PARK
New Street,
Cambridge **77**

75 NEW STREET, CAMBRIDGE
Special Permit Hearing
September 16, 2014
Package prepared by:
AbodeZ

Response to Planning Board Questions and Comments made at the July 22, 2014 Planning Board Hearing.

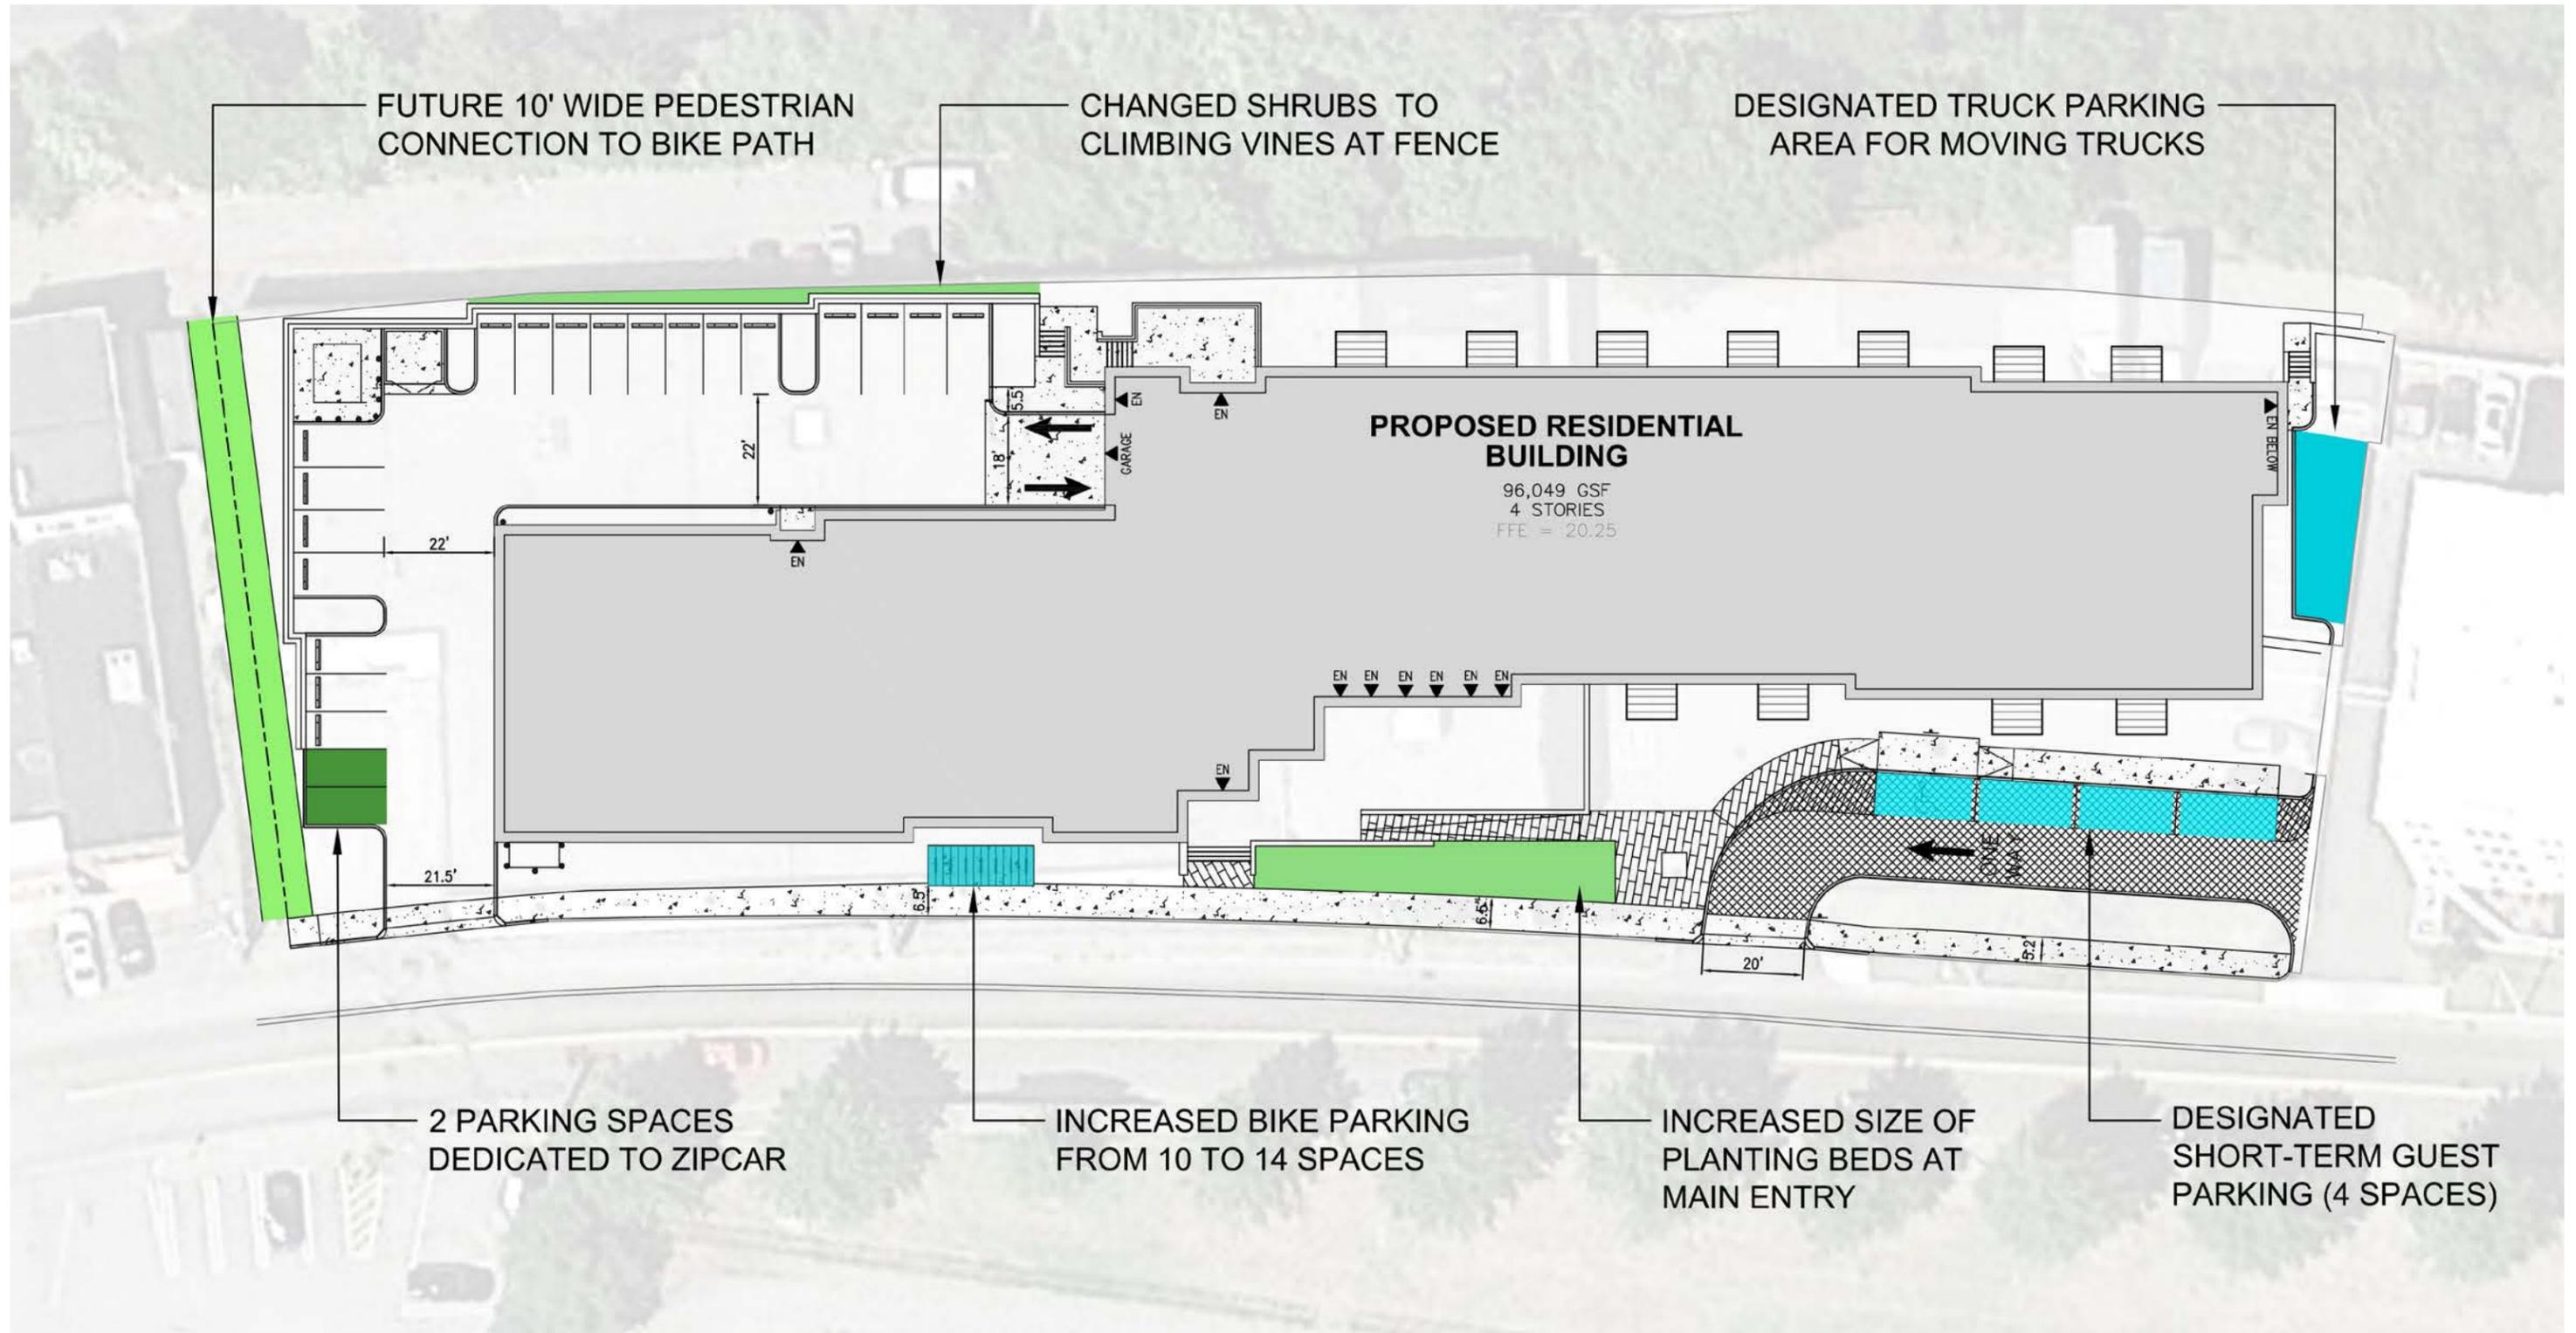
How will visitor parking be handled?

How will delivery trucks be handled?

Will there be enough room for shrubs along the west side of the lot, next to the parking?

Can you designate a path from New Street to the future bike path, without any stairs? It may connect to the adjacent Auto Body land at the rear of the site.

Show adequate planting along New Street.

There will be 4 unassigned visitor parking spaces in front of the building, at the main drop-off. These will be available on a first-come, first-serve basis during the day, and by guest parking passes at night. Overnight parkers without a guest pass will be towed. Refer to the attached site plan. We will also provide 2 ZipCar spaces as shown, near the entrance to the Phase II parking lot off of New Street

Short-term delivery trucks, (FedEx, UPS, Mail) will be able to live-park at the main drop-off in front of the building. Moving trucks will park at the northern end of the building, at the bottom of the existing parking ramp. This location will serve both buildings for move-ins. Refer to the attached site plan.

Our landscape architect agrees that there may not be enough room for the shrubs as shown, and has recommended we replace those shrubs with climbing vines which will grow on the fence and provide a visual screen between our parking area and the abandoned railroad right-of-way. Refer to the attached site plan.

We have designated a 5'-0" wide path at the south property line of our property. We propose that the adjacent property owner, (or future developer of that property), be required to allow a similar 5'-0" wide path on their property, so that the overall width of the path would be 10'-0" in the future. Refer to the attached site plan.

We have expanded the planting area in front of the main building entry in our latest plan. We have also proposed to add large-caliper street trees in wells along the new sidewalks in front of both of our buildings on New Street, (75 and 87 New Street), in accordance with our discussions with the Cambridge Department of Public Works. The final layout of curbs and trees is pending DPW design; however, we have shown a possible layout for these trees in the attached site plan.

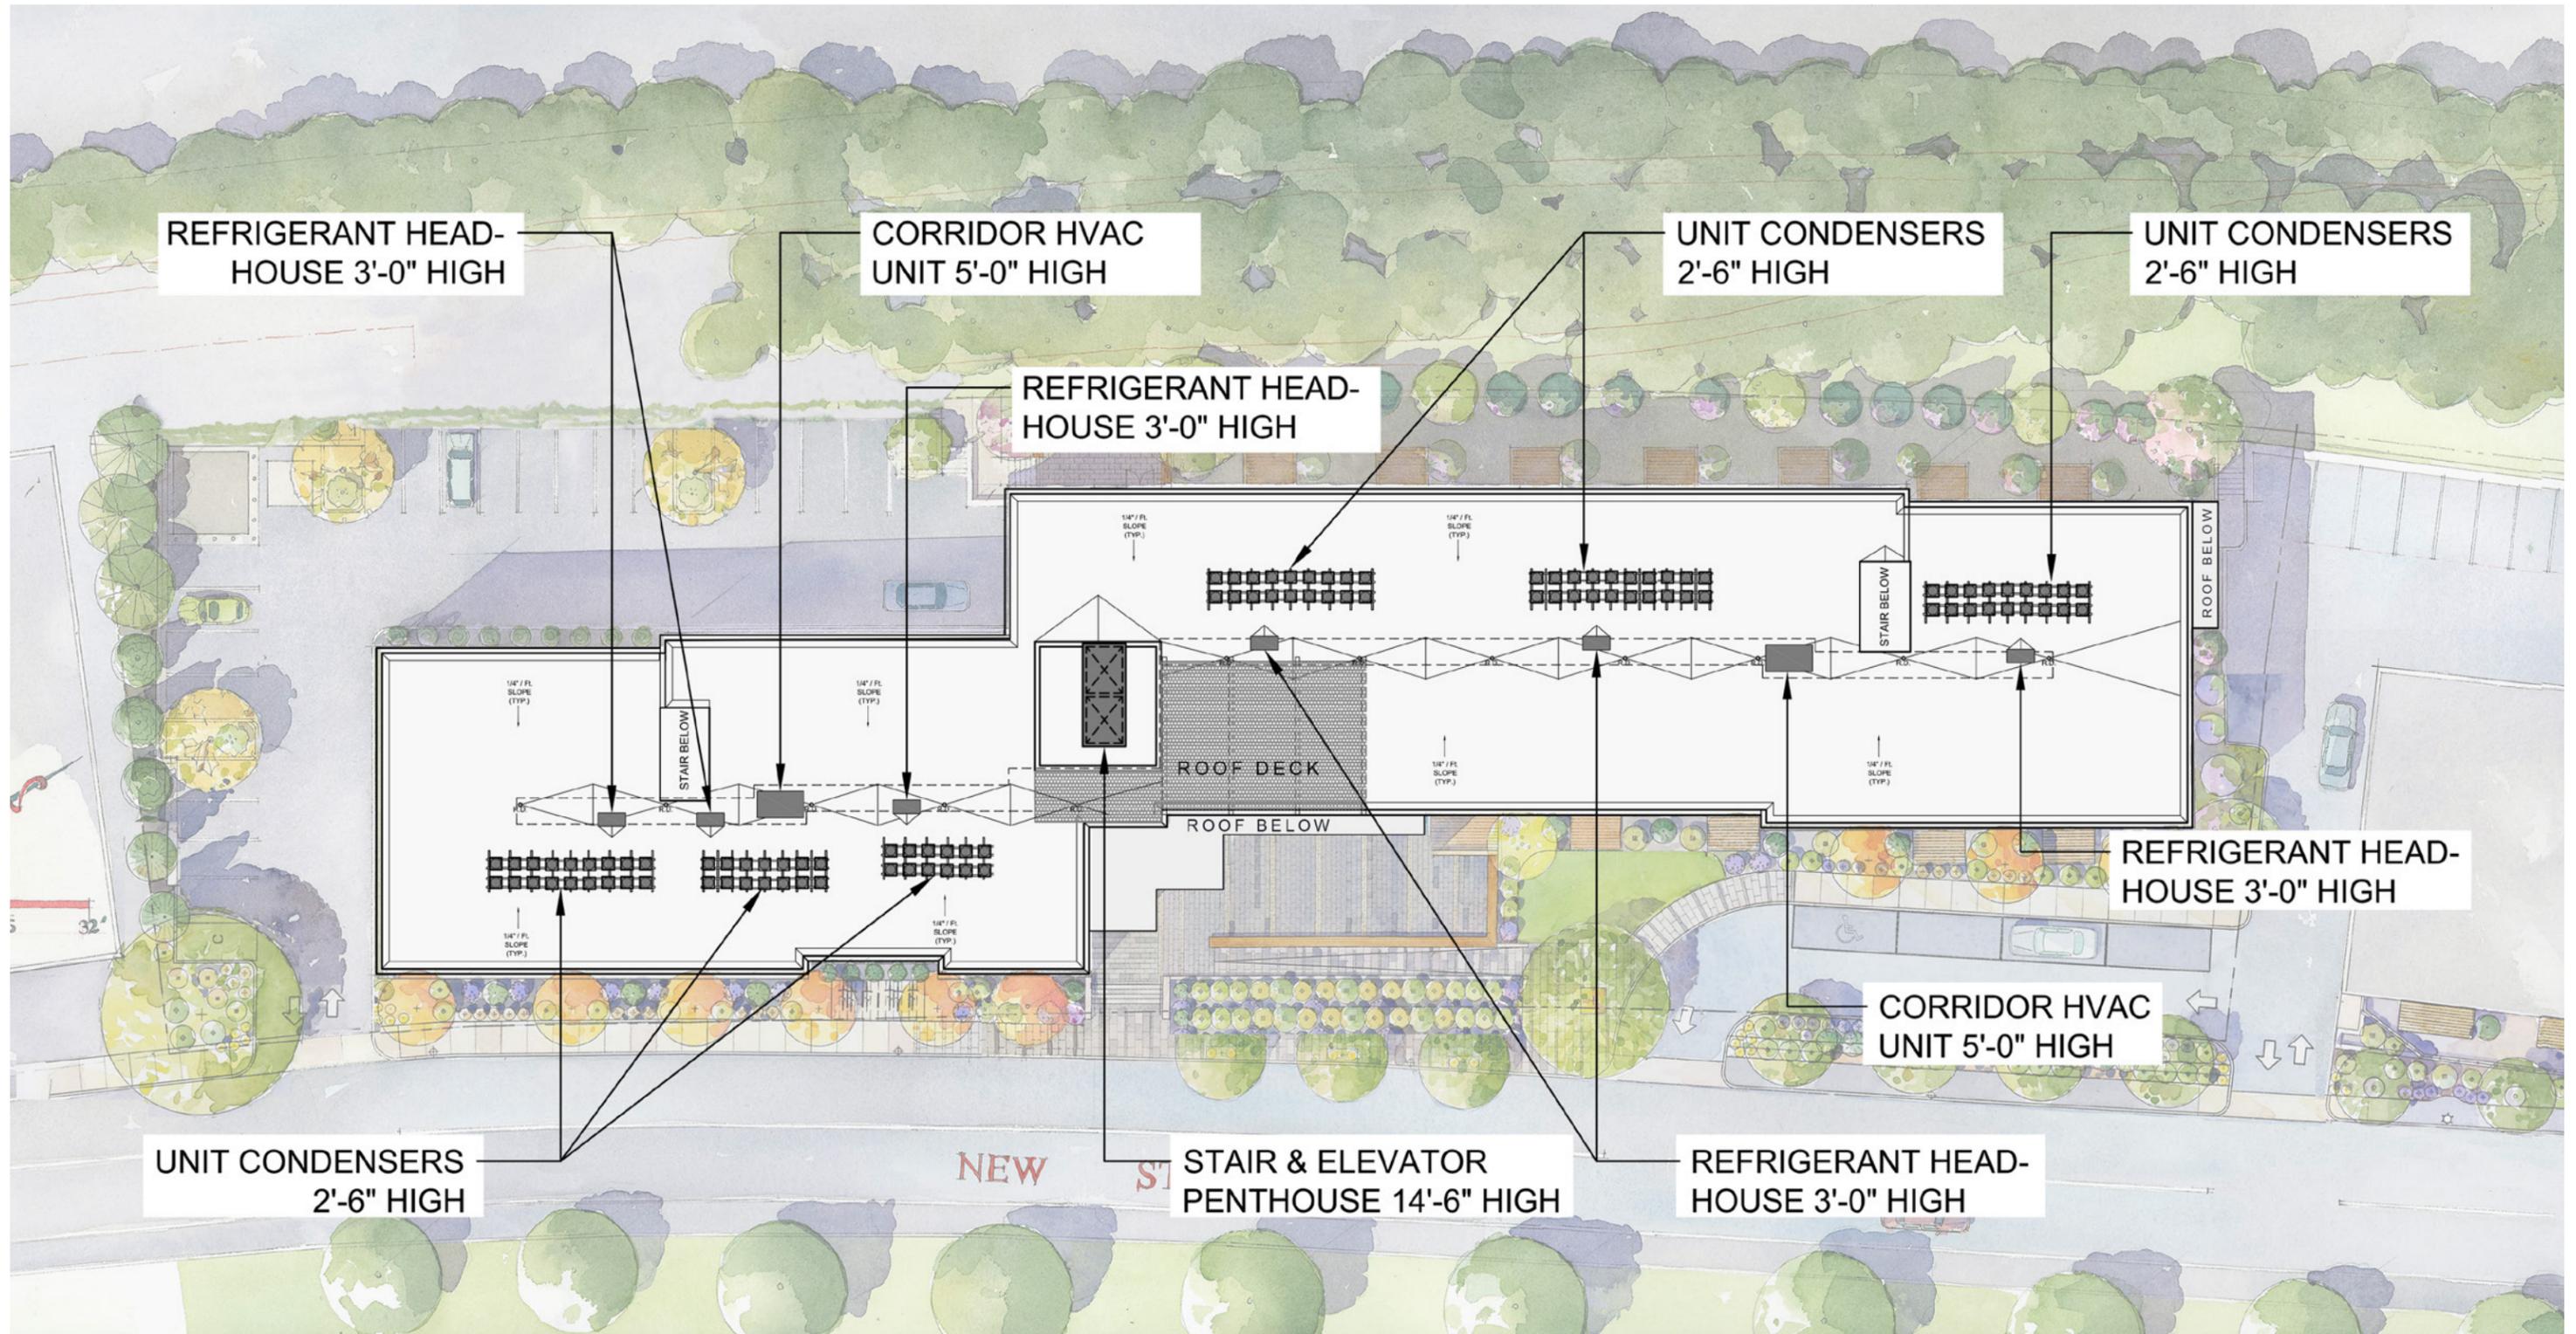
Show rooftop mechanical equipment and elevator penthouses in more detail.

Refer to the attached enlarged elevation and roof plan. Parapets around the perimeter of the building have been designed to screen rooftop units from view. The largest mechanical units will be located at the center of the building, at the low points (valleys) of the roof. The elevator penthouse is being designed to integrate with the rooftop trellis structures as shown.
